M1 Junction 15
Northampton Rail Freight Interchange

Stage 1 Road Safety Audit

Document Number:	NGW-BWB-GEN-XX-RP-TR-001_RSA1
BWB Reference:	NTH2315

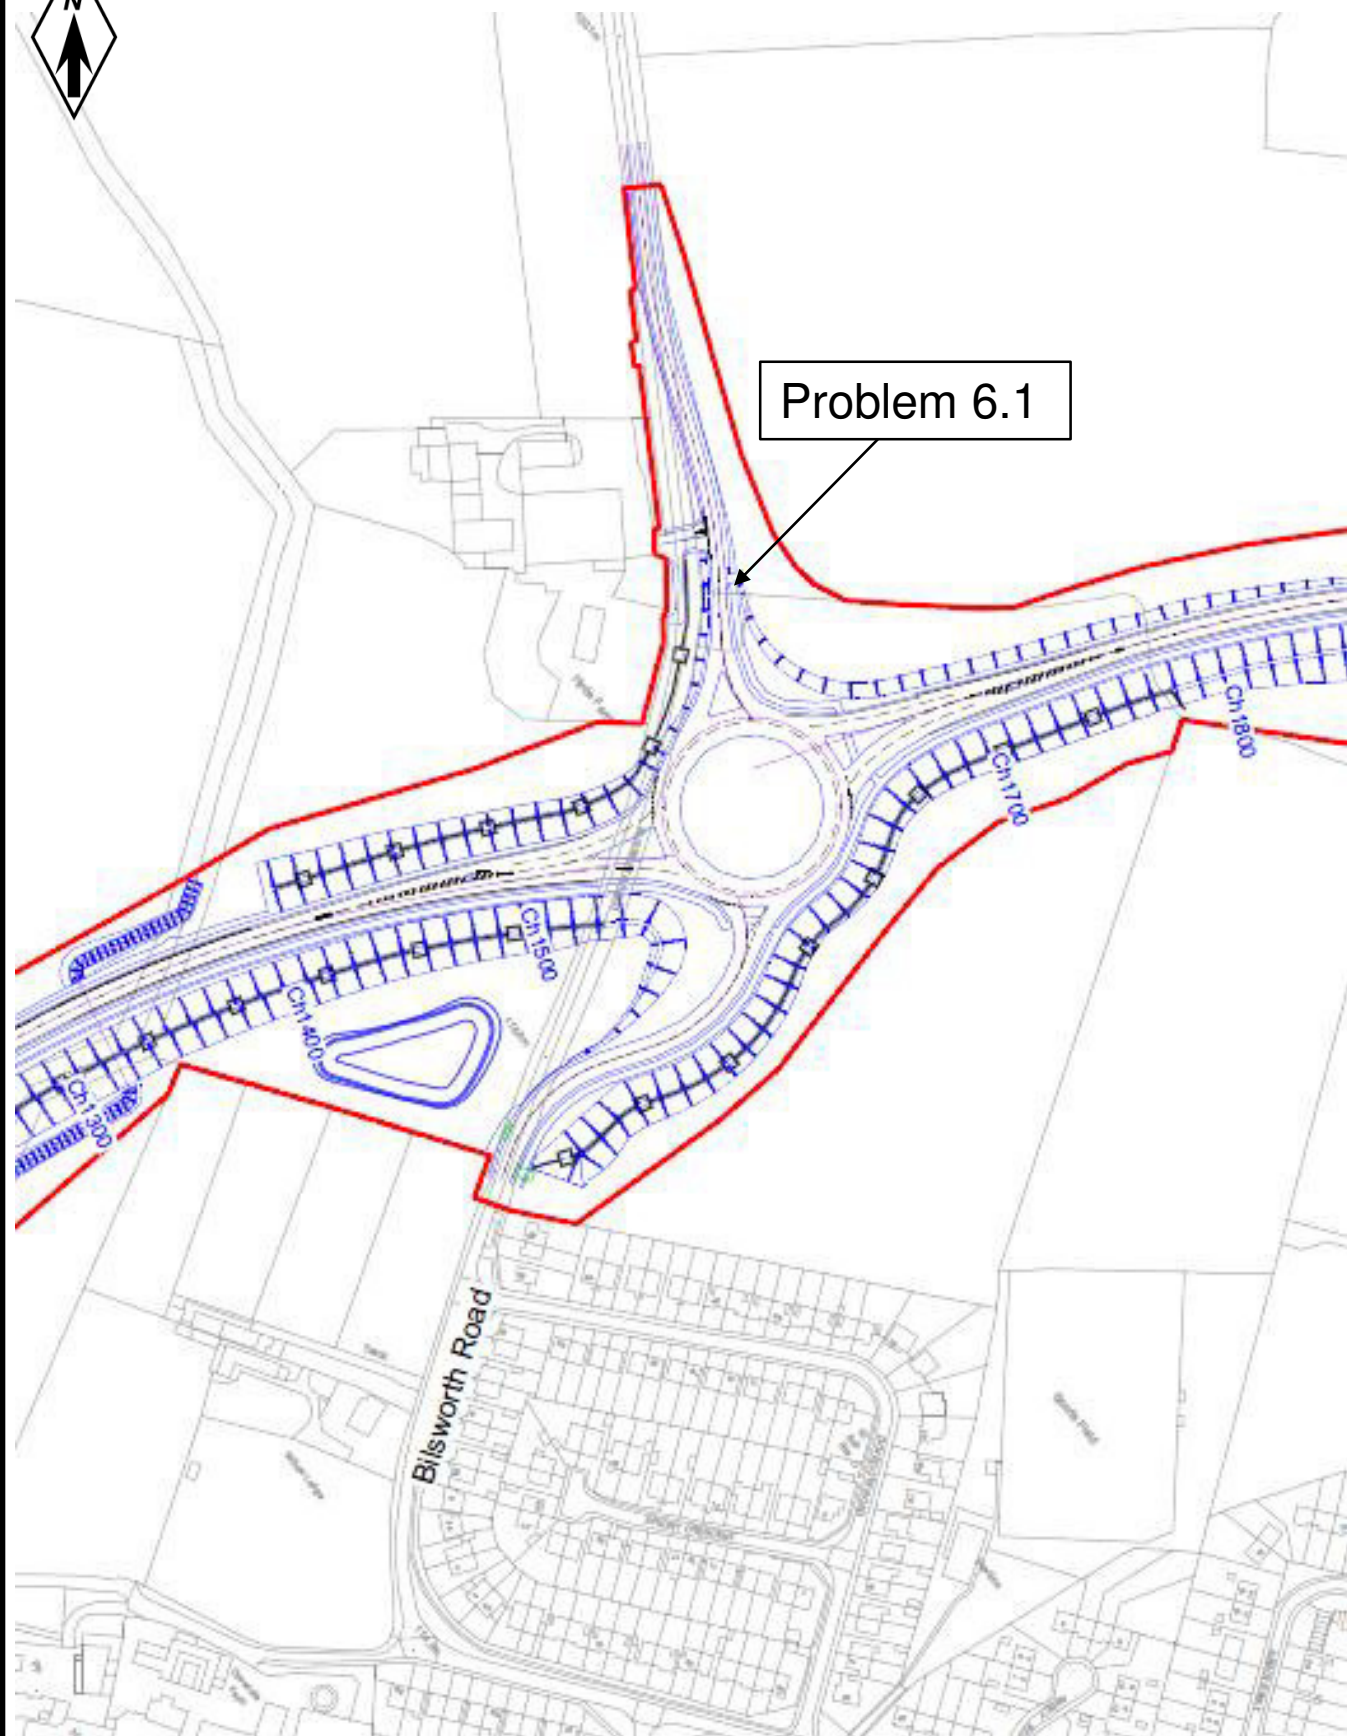
Summary: It is unclear how cyclists would connect onto the off-road cycle facility.

What is understood to be an off-road section of cycleway is proposed on the northeastern side of the Roade Bypass/Blisworth Road roundabout, to provide any cyclists from Blisworth with the opportunity to access the shared surface footway/cycleway on the eastern side of the bypass without travelling around the roundabout on the live carriageway.

However, the facility appears to begin at a newly created farm access. It is therefore unknown at this stage how cyclists would be safely directed onto said facility, avoiding any potential conflict that could be created by the farm access, including any mud on the carriageway which could cause cyclists to come off their bicycles.

Further thought is required as part of the detailed design process, as to how cyclists would safely access the off-road cycle facility. It may be beneficial to provide a separate dropped kerb facility closer to the roundabout, dedicated to cyclists leaving the carriageway to avoid any conflict with the farm access.

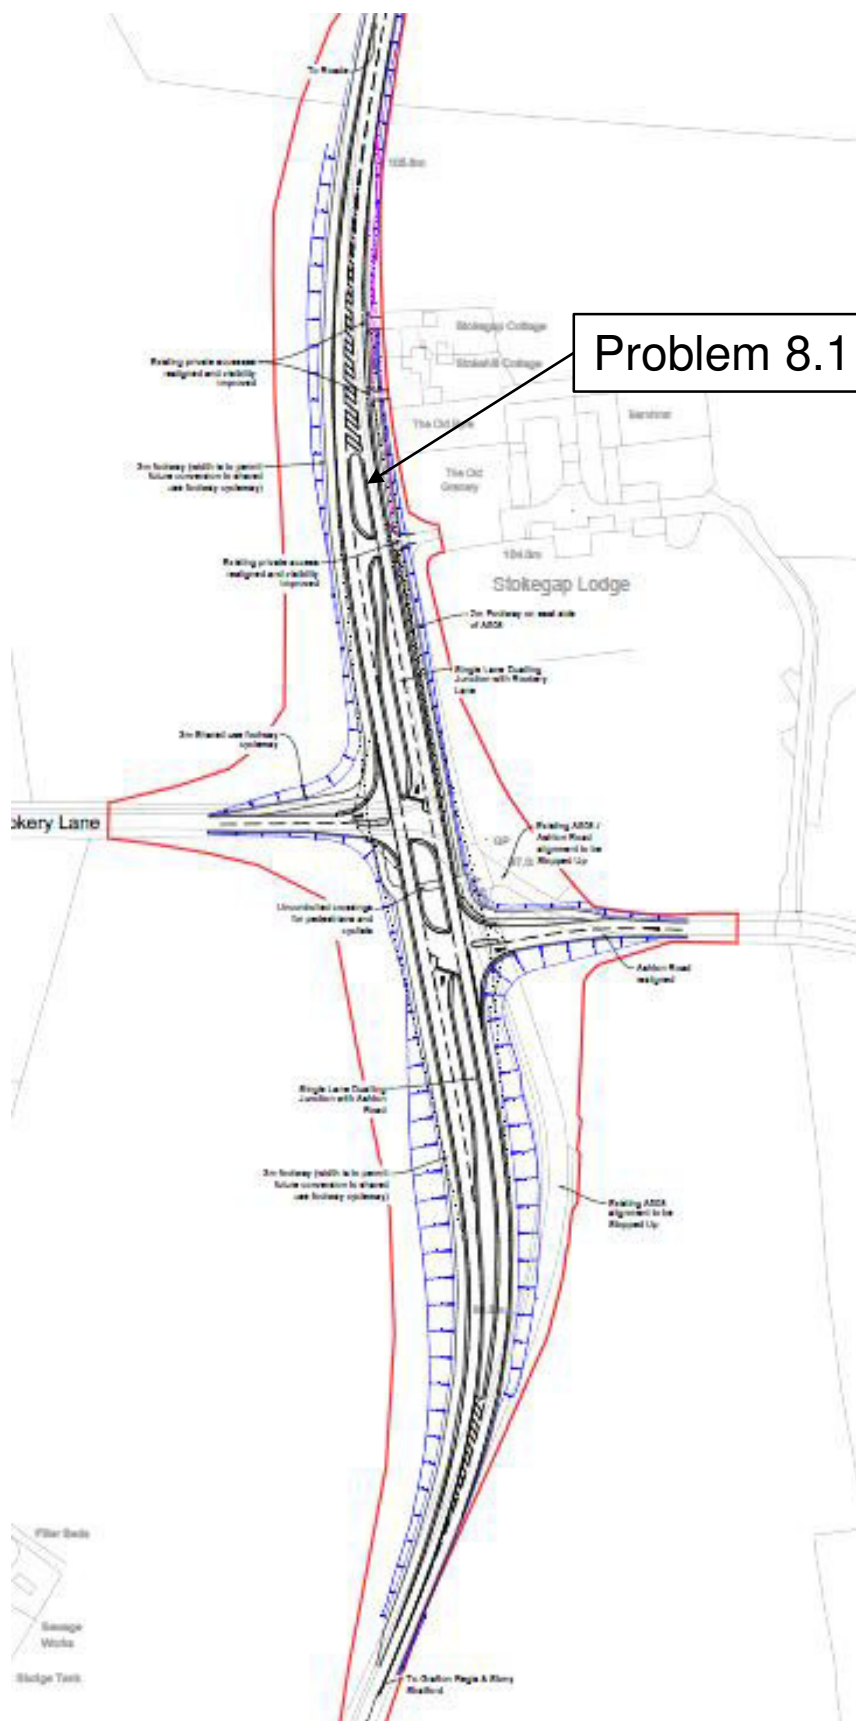
Summary: Lack of crossing facility provided between footways.

There is currently a footway provided along the eastern side of the A508 in the vicinity of the cottages, north of the proposed staggered junction. The proposals include a 3.0 metres wide shared facility on the western side of the A508. However, there is no facility provided to the north of the junction to allow pedestrians to cross the carriageway. This could result in pedestrians attempting to cross where there are no provisions or, where motorists are not expecting them to cross, resulting in them being hit by passing vehicles.

Provide an informal crossing facility across the most northern refuge, in the form of dropped kerbs and tactile paving to allow pedestrians to cross the road, outside of the cottages.

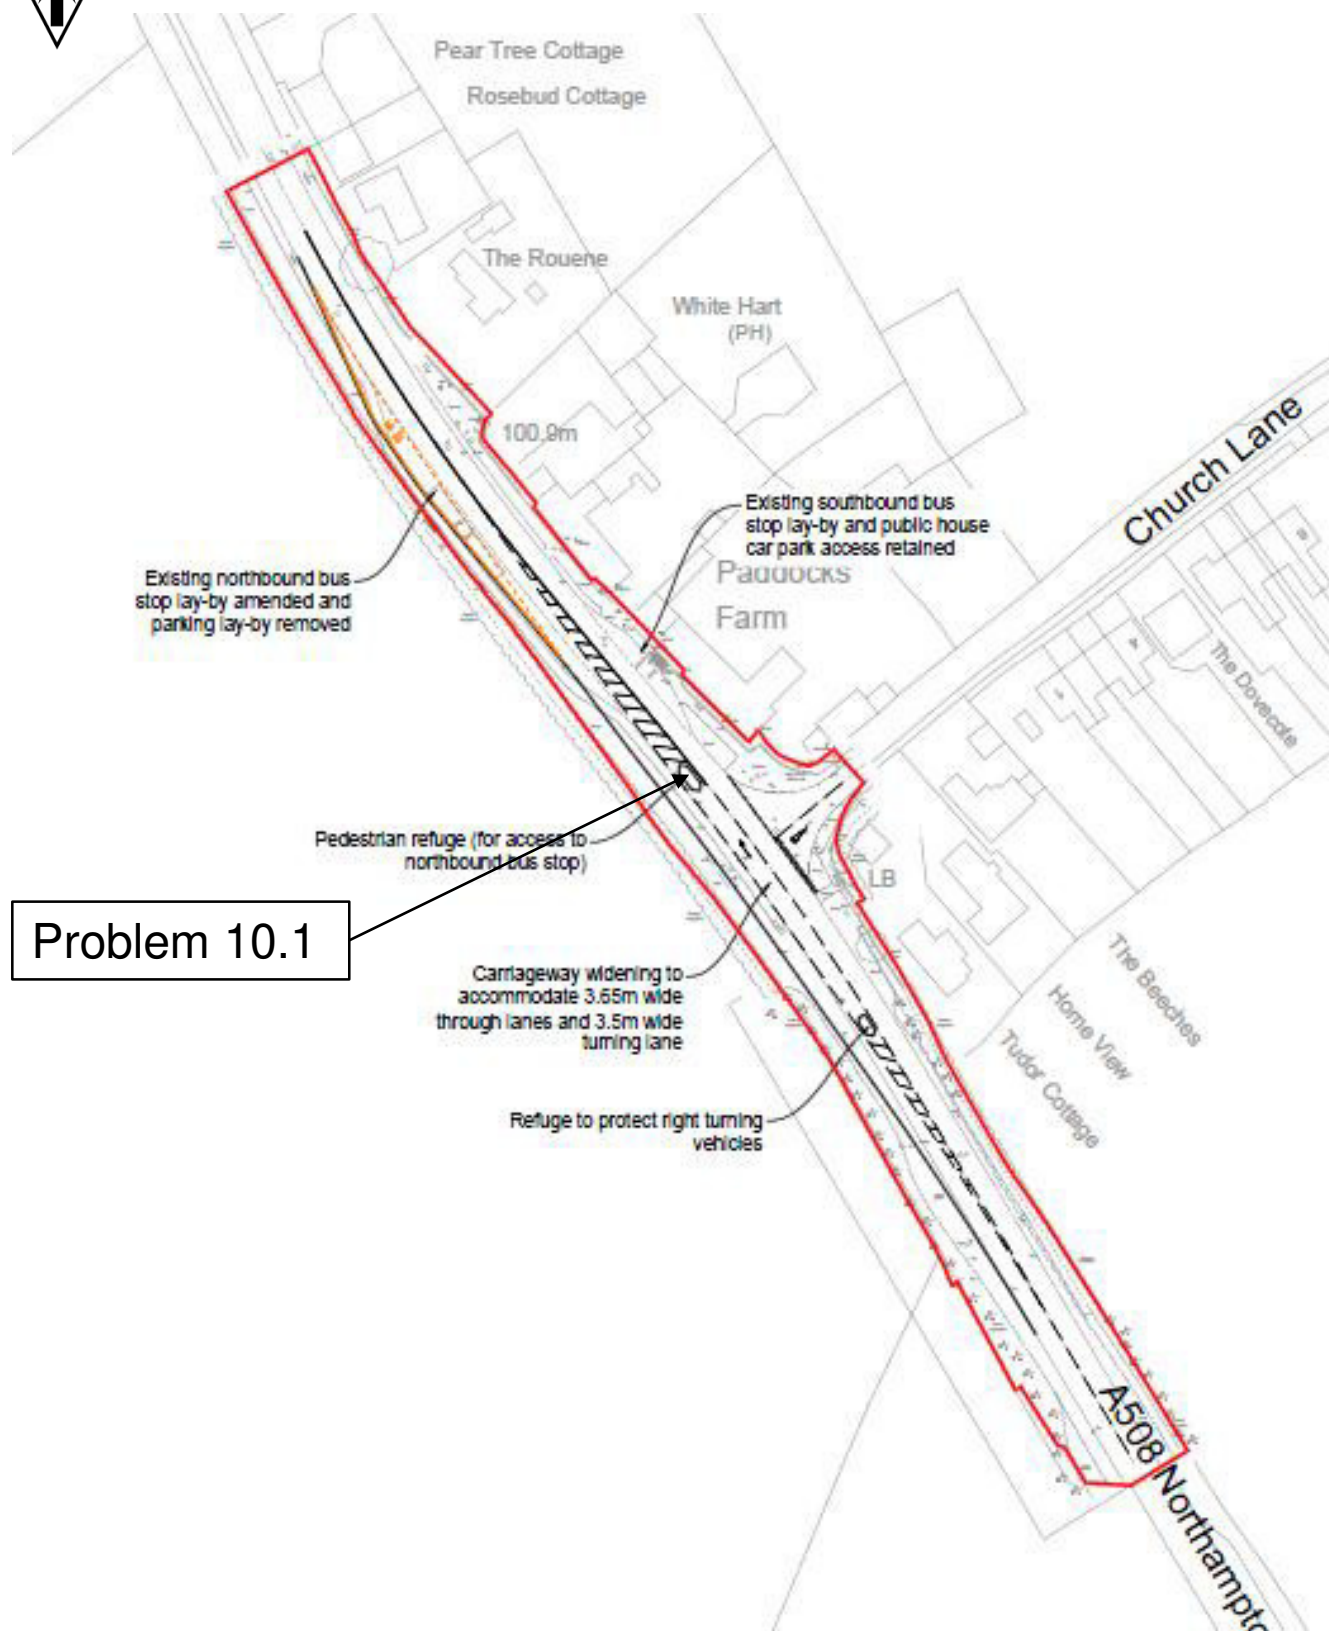
Summary: Refuge could be damaged by agricultural vehicles.

There is a refuge provided on the A508 directly to the north of the Church Lane junction, to allow pedestrian access to the southbound bus stop. During the site visit, a large tractor was witnessed turning right out of Church Lane onto the A508 which used a large amount of carriageway. If the refuge is provided close to the junction this could result in the refuge being run over by these large vehicles, potentially damaging the bollards or the kerbing, which could even leave parts of the kerb in the carriageway leaving a hazard to motorists and motorcyclists.

Ensure that the refuge is provided far enough from the junction to allow agricultural vehicles to enter and exit Church Lane.
